World Bank / Lake Chad Basin Commission

APPRAISAL OF THE SAFETY OF THE TIGA AND CHALLAWA GORGE DAMS, NIGERIA

March 2002

Upstream face of Tiga dam, looking west

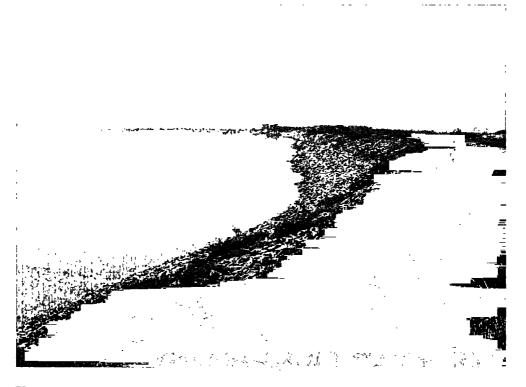
The upstream face of the dam is somewhat uneven as evidenced by an erratic shore line, as shown in the photograph: this observation tends to support poor construction control as suggested in the Haskoning report² although it could be a manifestation of post construction settlement due to poor compaction, which is also noted by Haskoning.

The upstream face is protected from wave attack by riprap which appeared, at the points where it was inspected, to have been dumped. As dumped riprap the average stone size is undoubtedly too small, as noted by the USBR team³. However the Haskoning report contains construction photographs in which the riprap was being placed by hand, a technique which in which smaller stones sizes can be tolerated. It is quite possible that the smaller stone specified for hand placing was retained even though the method pf placing was changed, presumably to speed progress. The consequence of inadequate stone size is of course higher maintenance costs. In addition there is a considerable amount of weed growth through the riprap layer which will further reduce its effectiveness in dissipating wave energy.

As has been noted the stone size of the riprap is inadequate to protect the wave erosion. The replacement of the riprap layer, especially at the higher levels, would be very desirable but is probably unrealistic in the short term. It is particularly necessary therefore that the riprap is subject to annual inspections and remedial works where necessary to repair any damage.
